ADDENDUM NO. CC-2

TELEGRAPH DISTRICT
401 BUILDING RENOVATION
LINCOLN, NEBRASKA
DLR GROUP PROJECT NO. 10-16202-00
MARCH 18, 2016

COMBINED CONTRACT

HVAC PLAN, FIRST LEVEL
SCALE: 1/8" = 1'-0"

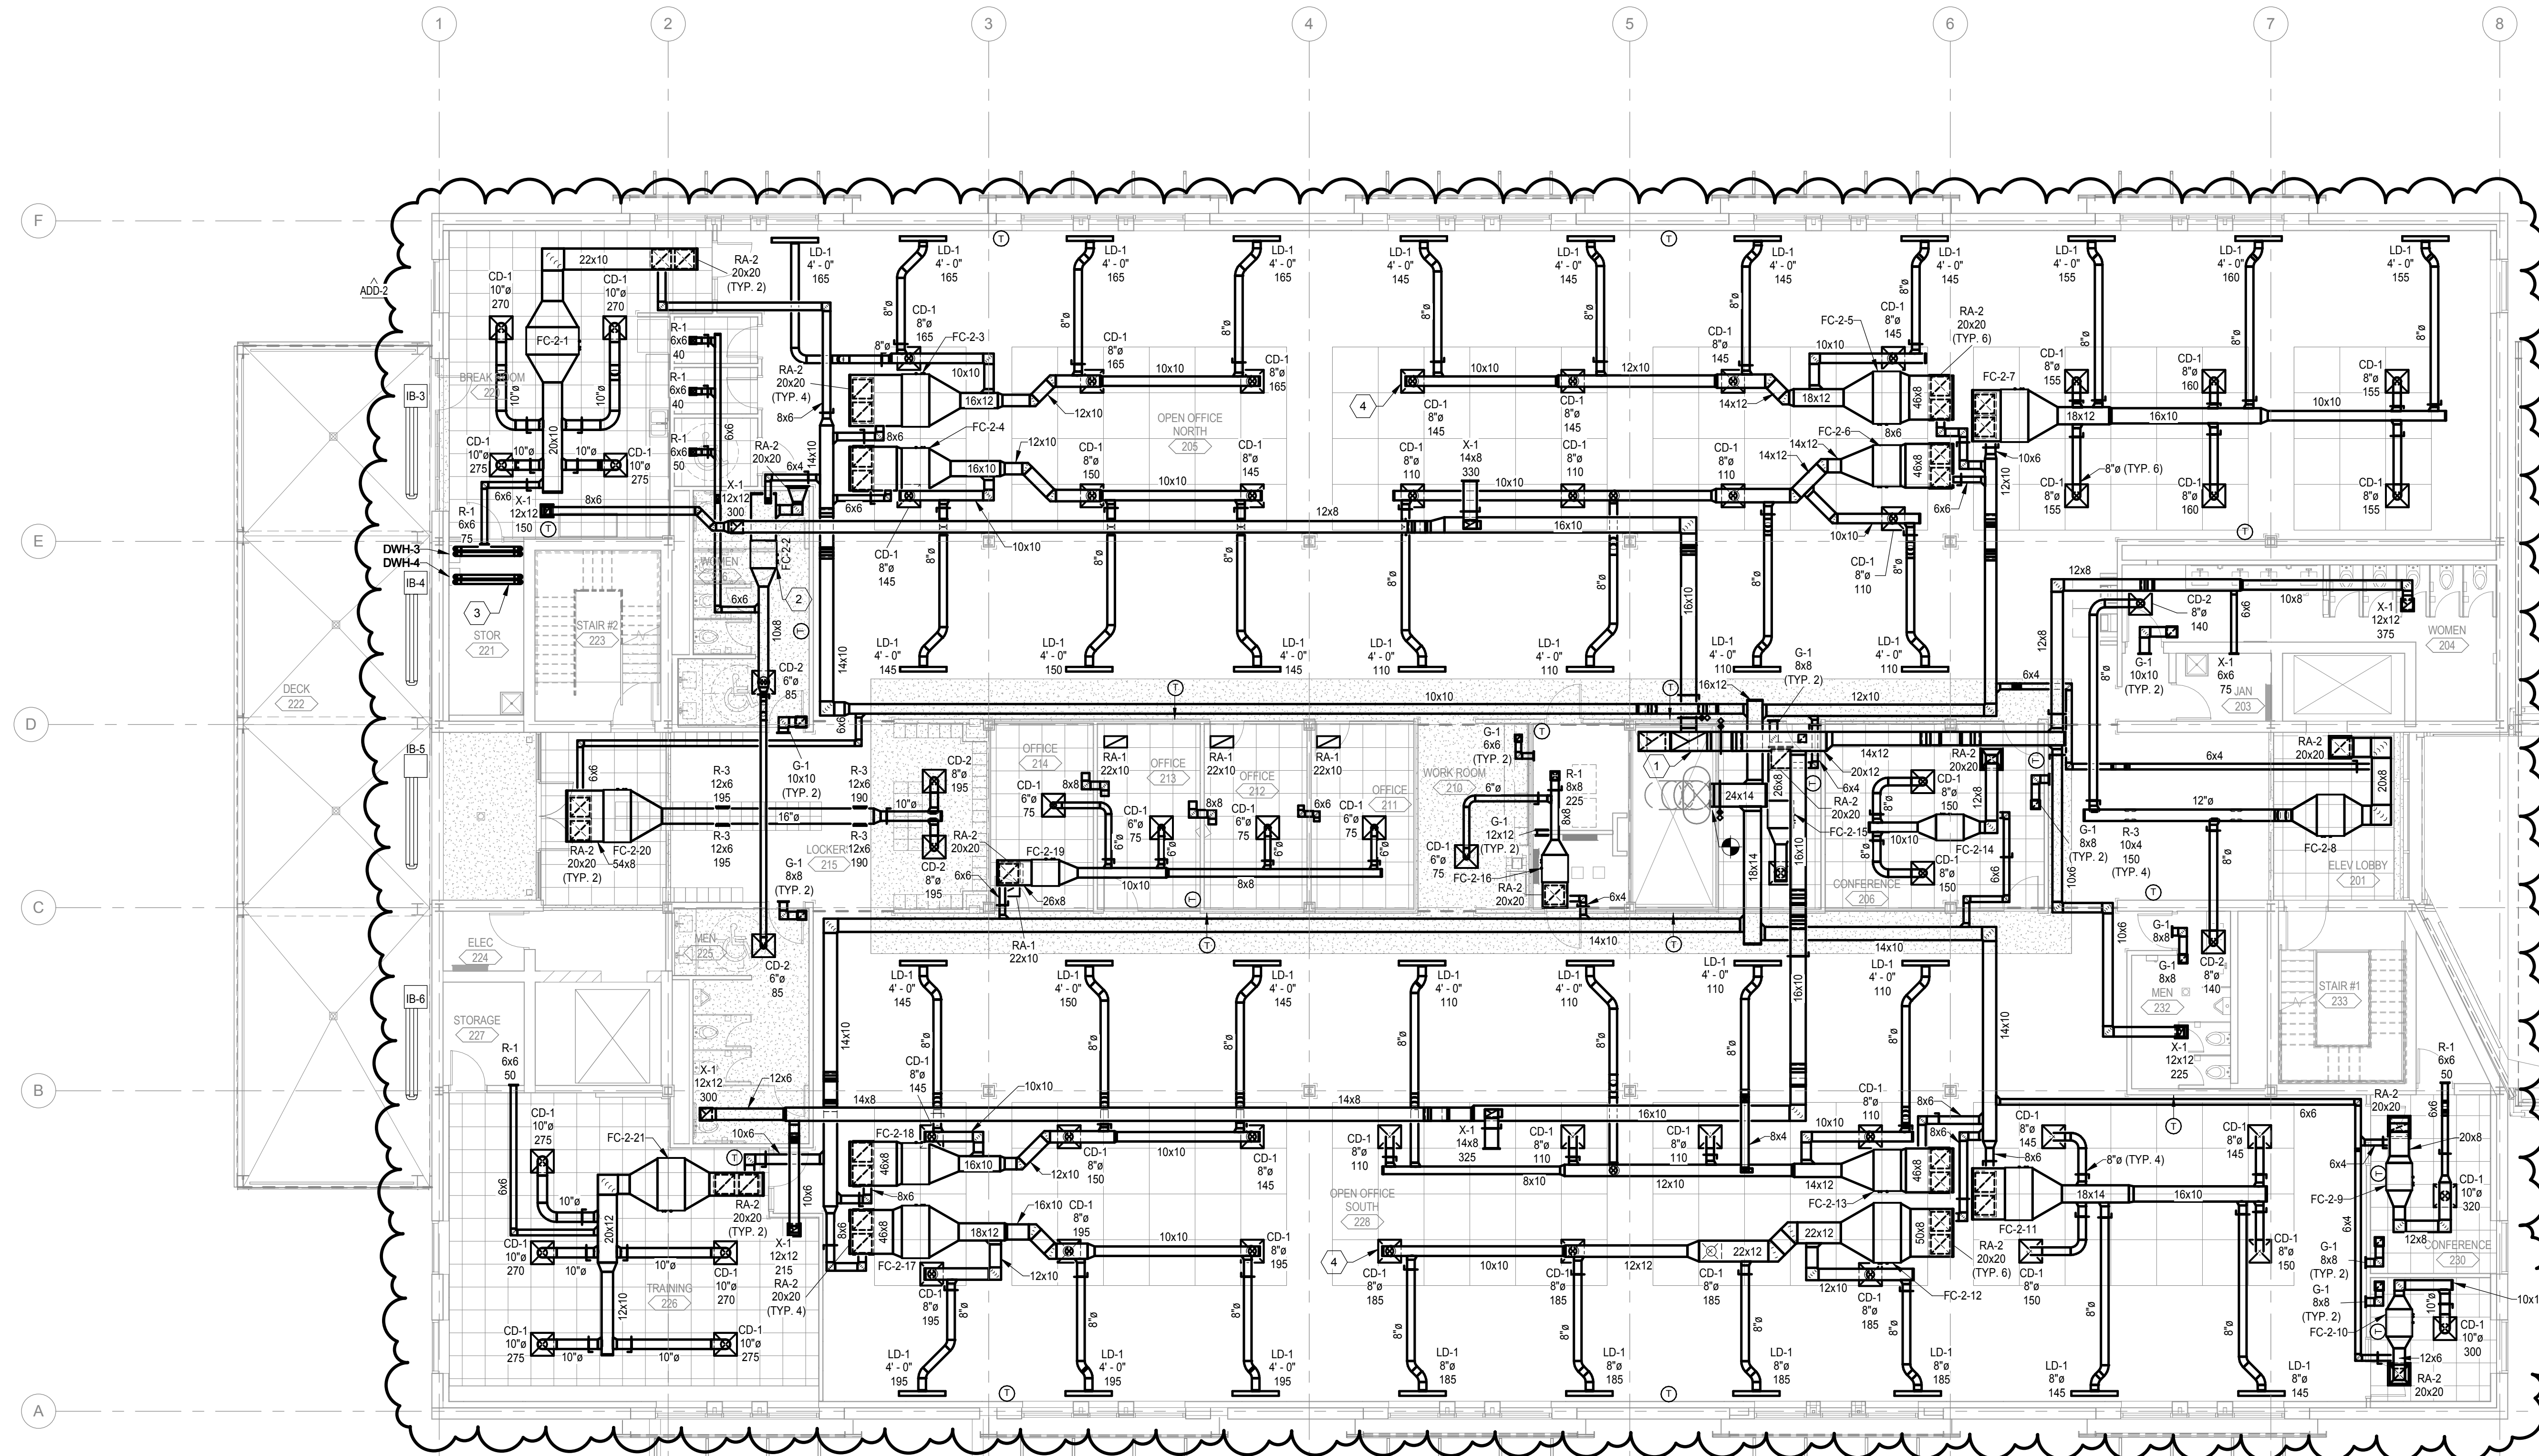
ITEM NO. 12 DRAWING M1.1 HVAC PLAN, FIRST LEVEL

- A. Revise the drawing as shown in the attachment M1.1 for modifications to the HVAC plan.

HVAC PLAN, SECOND LEVEL
SCALE: 1/8" = 1'-0"

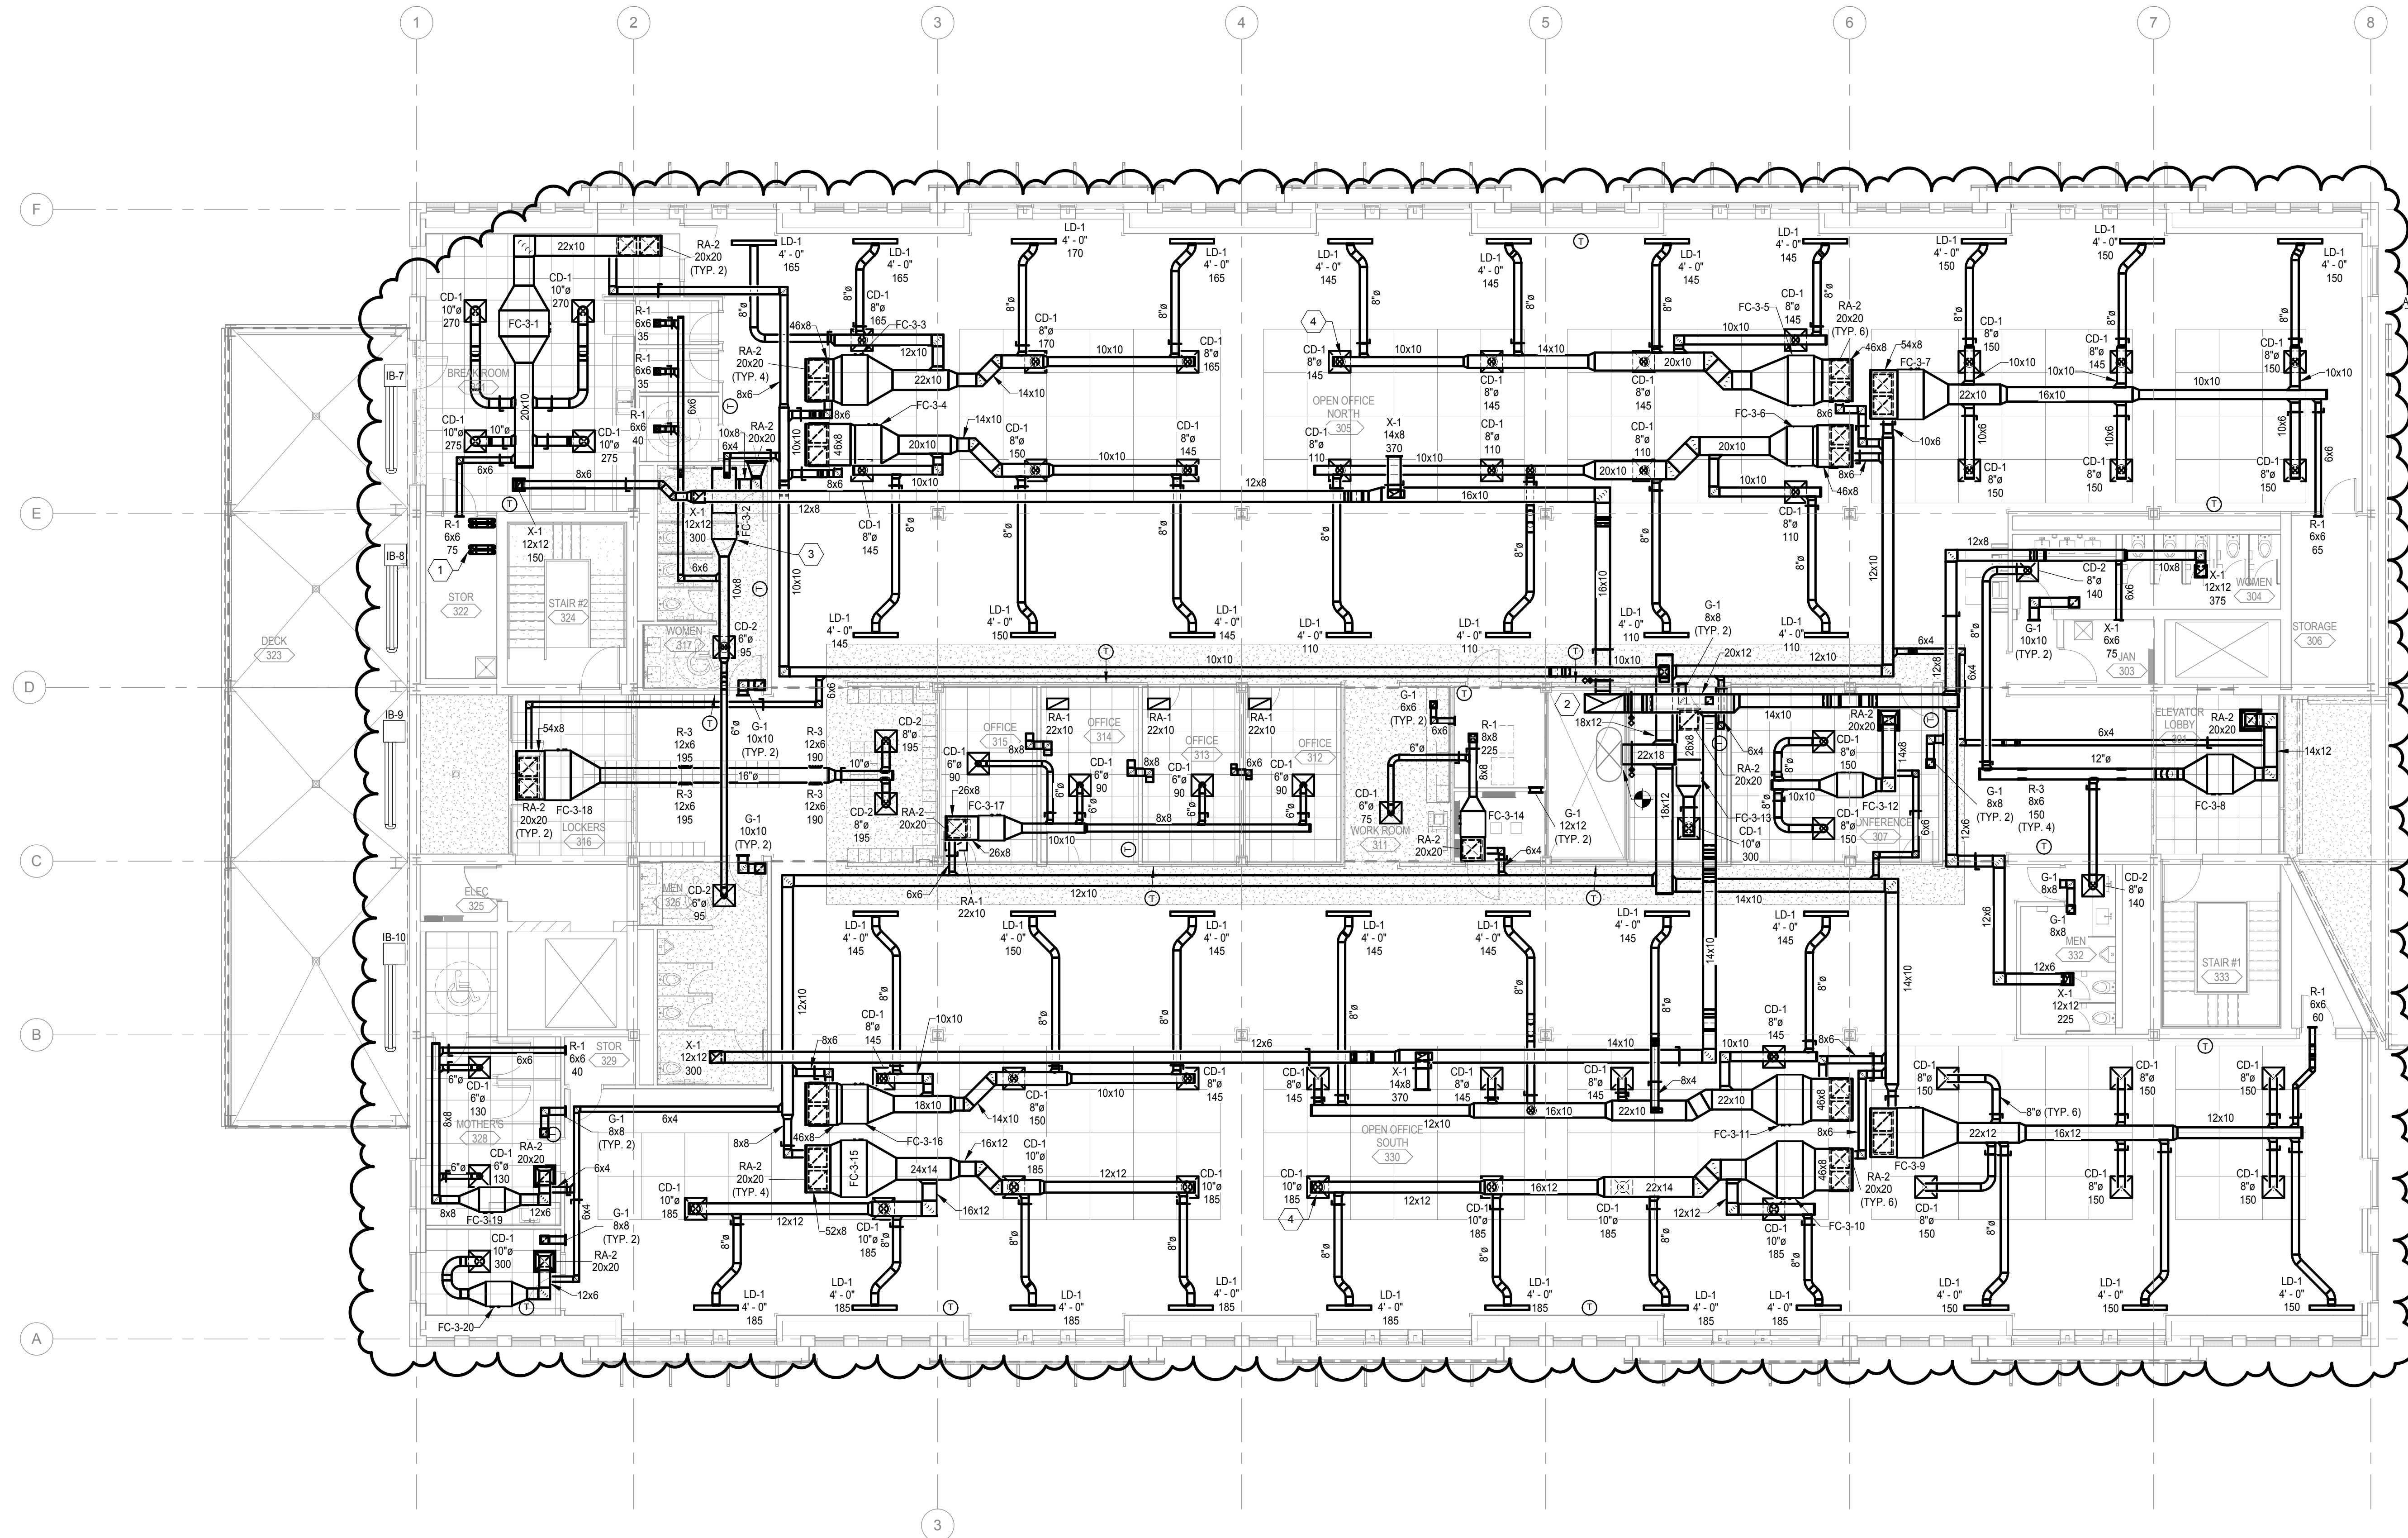
ITEM NO. 13 DRAWING M1.2 HVAC PLAN, SECOND LEVEL

- A. Revise the drawing as shown in the attachment M1.2 for modifications to the HVAC plan.
